MECHANICAL

REVIEWED
FOR
CODE
COMPLIANCE
09/28/2022

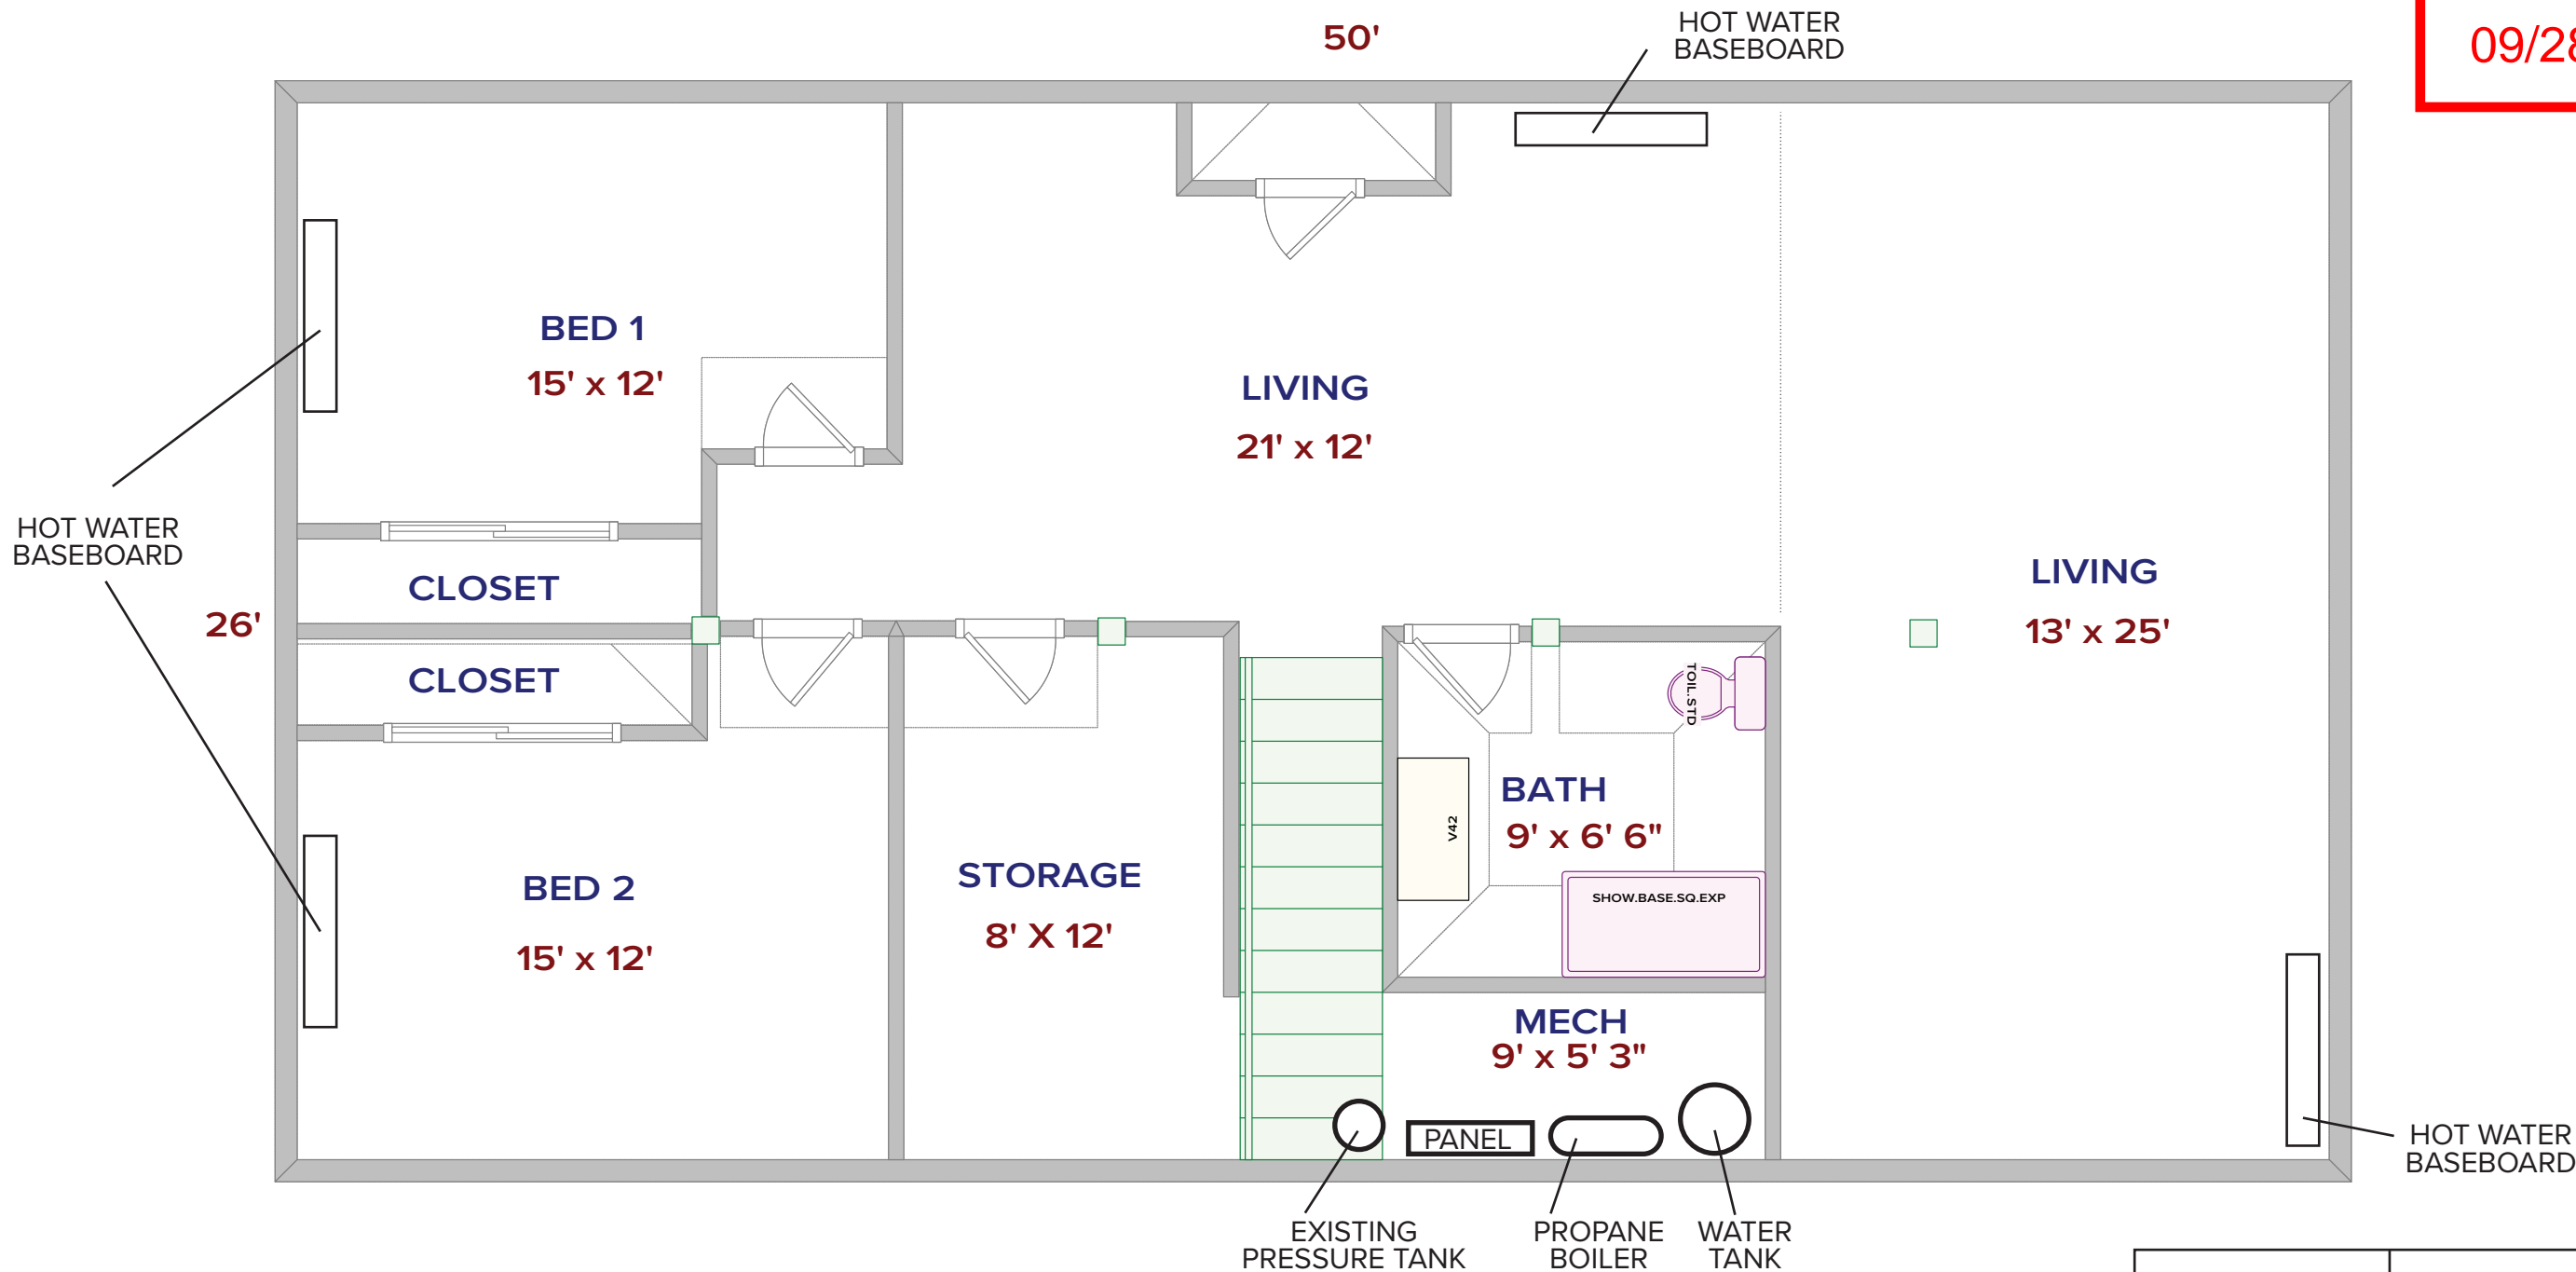
- Provide Window Well Ladders.
- Provide Mechanical Ventilation in accordance to Table M1505.4.3(2). 45 CFM
- Provide Artificial Lighting to meet requirement - *light is provided that is capable of producing an average illumination of 6 footcandles (65 lux) over the area of the room at a height of 30 inches (762 mm) above the floor level.*
- Provide AC powered smoke detectors with battery back-up where required by code.
